Pre-Plaster Report

Inspection Date: 6 Jul 2021

Property Address: 3 Madel Avenue Strathmore, VIC, Australia

Non Compliant 2.02

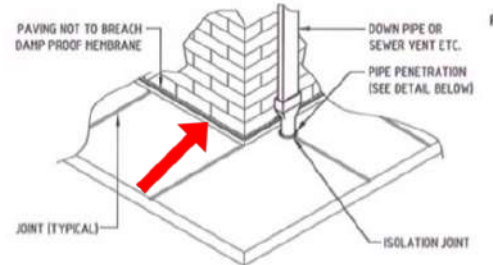
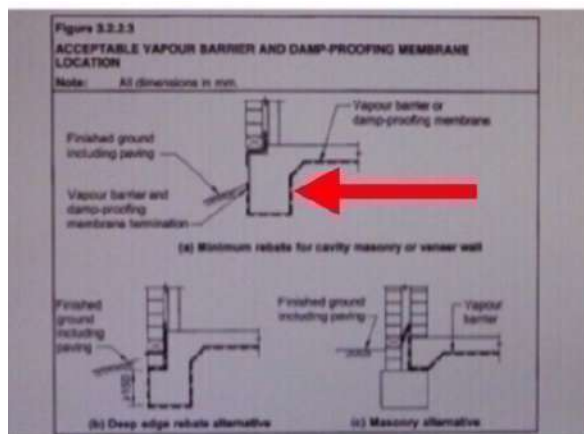
Finding: Vapour barrier - Defective (AS2870- 2011)

I HIGHLY RECOMMEND that the builders dig the perimeter carefully,, sometimes the entire perimeter, pending of the severity of the vapour barrier (plastic) damage, pending on slab over pour, pending on excessive builders concrete (debris).

The builder has not completed the vapour barrier system to the porch area and the alfresco area concrete perimeters.

It is a requirement of AS 2870-2011 5.3.3.4 that vapour barriers are turned up and terminated at ground level above pavement adjacent footing. The vapour barrier is defective if building materials and fill has been left on top of the membrane, as this prevents it from being pulled up against the slab when installing perimeter paving as it is intended to be.

It is important to dig along the slab perimeter without damaging the plastic and to extend the vapour barrier plastic higher then the slab rebate as would have been in the post slab report if we performed one.

All over laps must be a minimum of 200mm and the correct tape must be used to seal the plastic.

This must be remedied immediately to prevent slab edge dampness.

Non Compliant 2.03

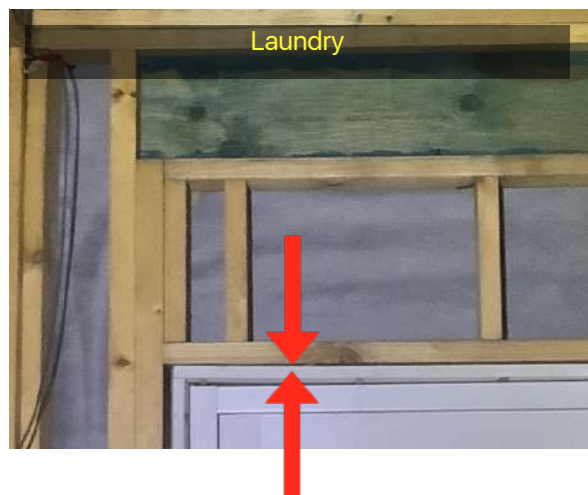
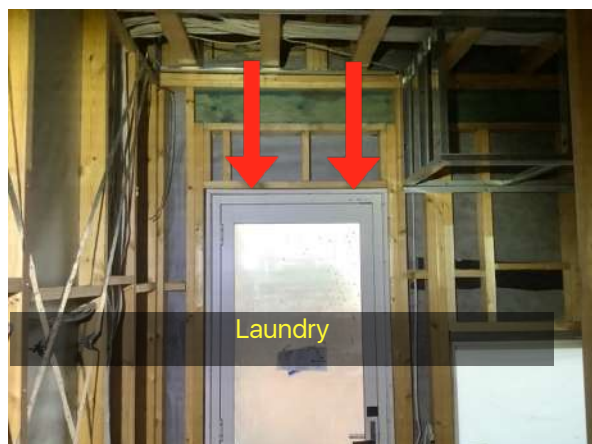
Finding: Top Of Window - Undersized Gap.

There are areas where the top of the windows are currently tight or well under 15mm to the underside of the timber lintels.

It is a requirement of Australian Standard, A.S 1684 Residential Timber-Framed Construction, clause 6.2.3 Openings, that 'A minimum clearance of 15mm shall be provided between the underside of the lintel or lintel trimmer and the top of the window frame'.

This opening and/or ALL openings that are under 15mm must all be modified in compliance with the above.

Non Compliant 2.05

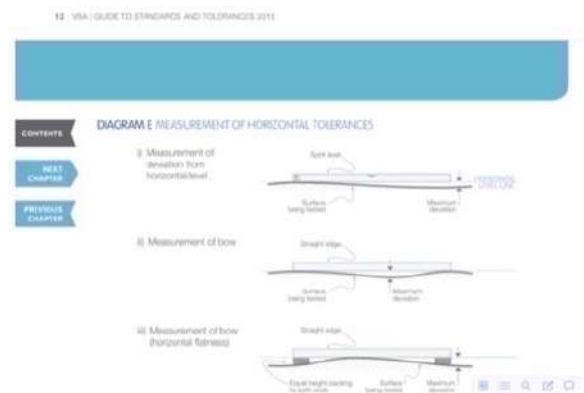
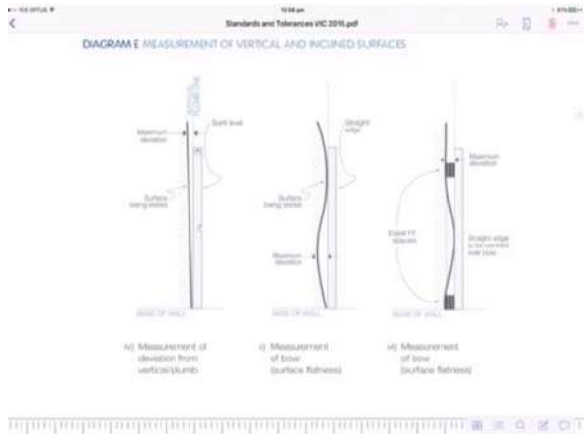
Location: All Areas
 Finding: Frame / Posts - Not Square / Level Vertically (Max variation is 4mm over 2 mtrs).

It is observed that post/s and wall frame/s are defective as there is a deviation from a vertical or straight plumb line which exceeds 4mm within any 2m of height / length.
 This is a technical defect and may result in subsequent structural defects if left unmanaged.

Any deviation in excess of 4mm exceeds the allowable Standards and Tolerances and is considered a defect, in which the builder must attend to prior to the plaster installation.

Non Compliant 2.06

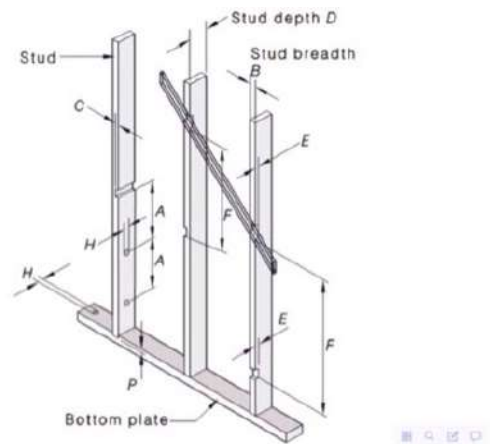
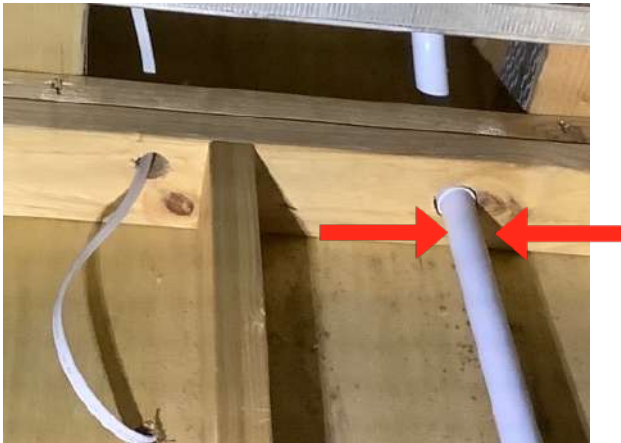
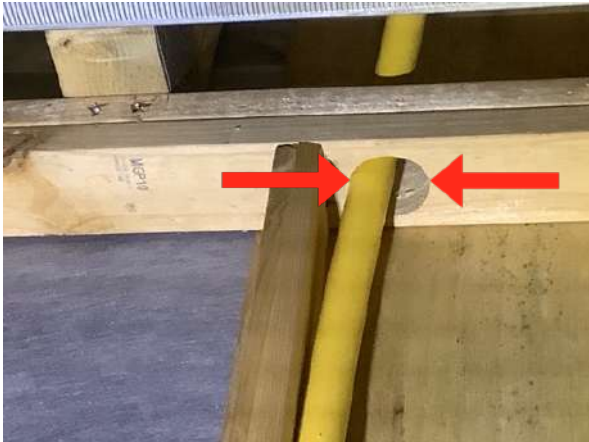
Finding: Services holes and penetrations - over sized

It was observed during inspection that the diameter/size of holes and penetrations exceeded the maximum size allowable as defined in AS1684.

AS1684 states that service penetrations to studs and plates shall not exceed 25mm and shall be placed central to the breadth or width of the member.

Generally with holes that exceed 25 mm in diameter a recommendation is just to install a noggin with two nails to each end into the studs and three nails into the top plate.

Non Compliant 2.07

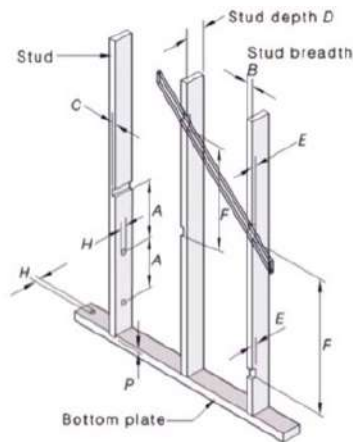
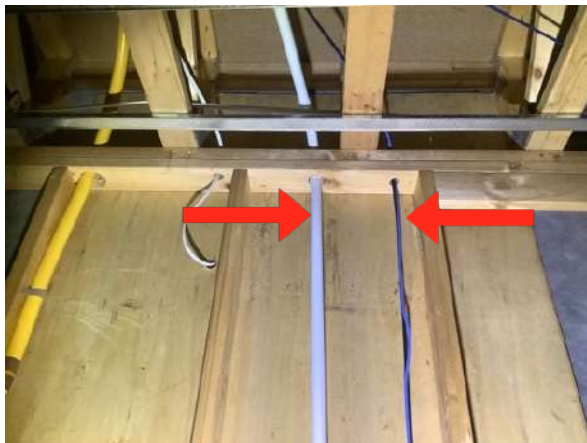
Finding: Holes and notching - insufficient distance.

It was observed during inspection that the minimum distance between holes for services (electrical and / or plumbing) and notching has not been maintained. The AS1684.2 2010, Page 60 and 61 requires a minimum distance between holes and notching in a 90mm stud and top plates is 270mm apart.

The standard (table 6.1) states that the distance between holes and other holes or holes to notches in studs can be no closer than $3 \times D$. This is calculated as $3 \times$ the depth of the material used. In this case $3 \times D$ is $3 \times 90\text{mm}$ or 270mm minimum distance apart.

Non Compliant 2.09

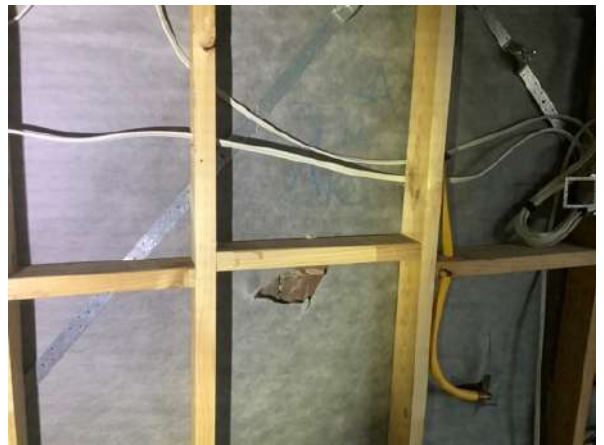
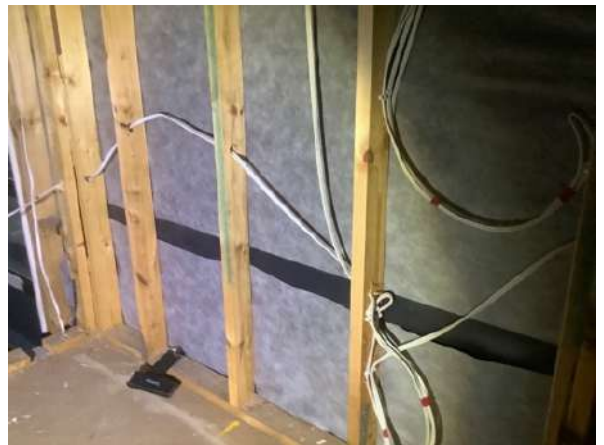
Finding: Sisalation - not installed correctly, deterioration and damage.

It was observed that sisalation has not installed correctly, deterioration and damage. during construction. Poor or substandard installation combined with damage may result in secondary defects developing affecting weather tightness and environmental efficiency rating for the construction.

Additionally it was observed that the sisalation has not been installed as per the manufacturers specification and the AS which states that lapping of sheets must be 150mm.

All damaged or removed sections must be repaired prior to works continuing especially if a construction is a "reverse build".

Where sisalation is damaged and cannot be made as new. The damaged sections will need to be replaced with new prior to proceeding with the build. I refer the builder to the section of the contract on this topic.

Non Compliant 2.10

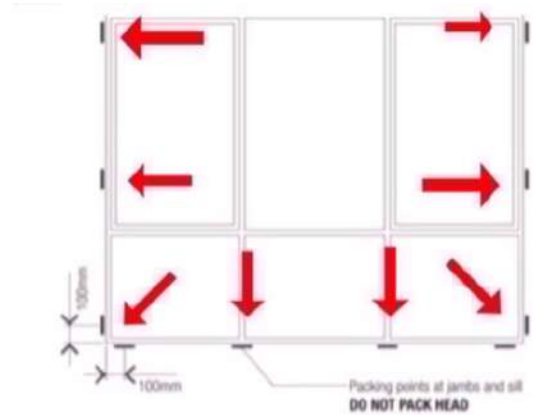
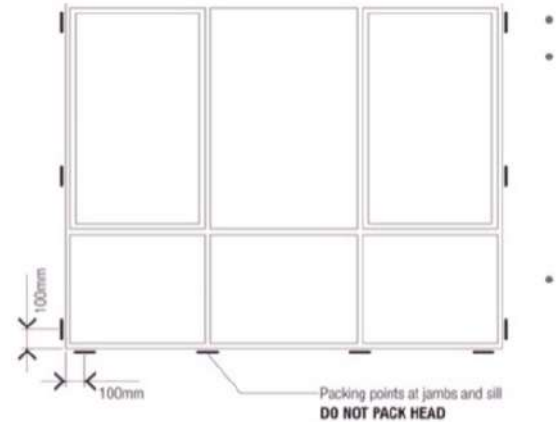
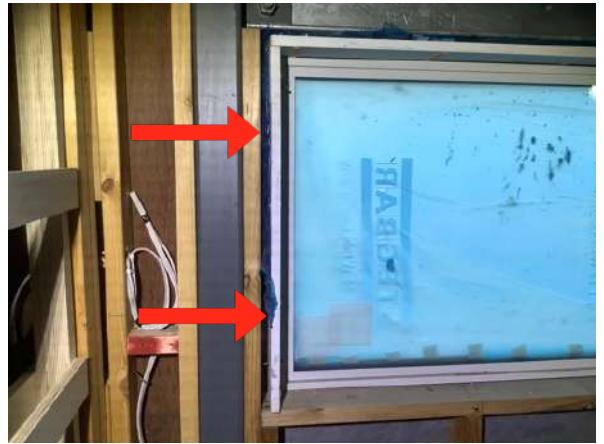
Finding: Windows - No Packing, As Per The Manufactures Specifications. (Or Packing Not Satisfactory)

Windows must be packed at the mullions as specified by the window manufacturers specifications.

In this case the defect in discussion is the sides of the window and the bottom of the window DO NOT have a sufficient gap if any to allow for movement and compression of the frame.

ALL WINDOWS with no or insufficient gaps, also as per manufacturers standards is packing to the sides and bottom of the windows as well, must be reworked to allow a recommended of at least 15mm to 20mm of packing.

The packers must be as the manufacturers specifications.

Non Compliant 2.11

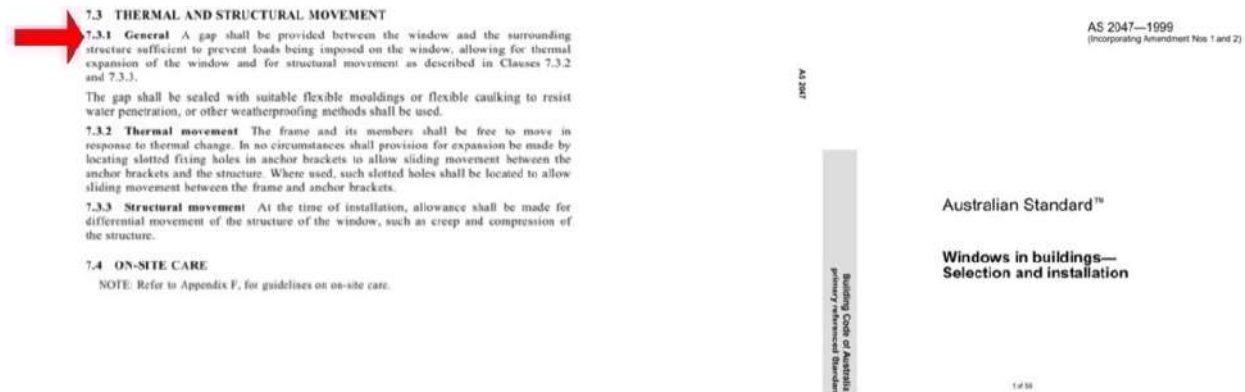
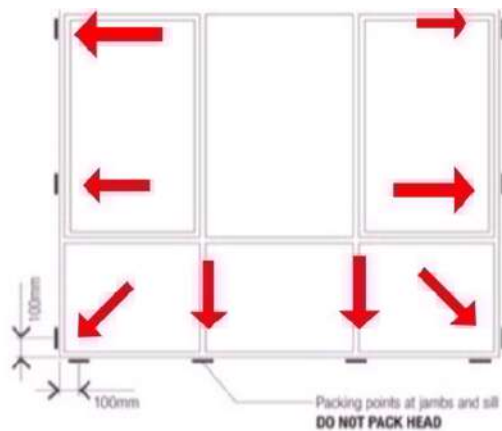
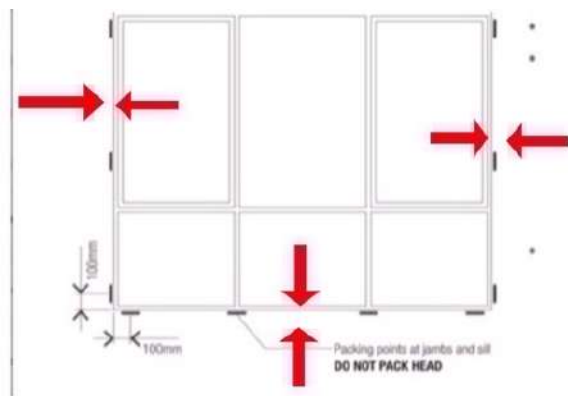
Finding: Window Installation - Gaps To Perimeter Of Windows Defective.

In this case the defect in discussion is the sides of the window and the bottom of the window DO NOT have a sufficient gap if any to allow for movement and compression of the frame.

ALL WINDOWS with no or insufficient gaps, also as per manufacturers standards is packing to the sides and bottom of the windows as well, must be reworked to allow a recommended of at least 15mm to 20mm of packing.

The packers must be as the manufacturers specifications.
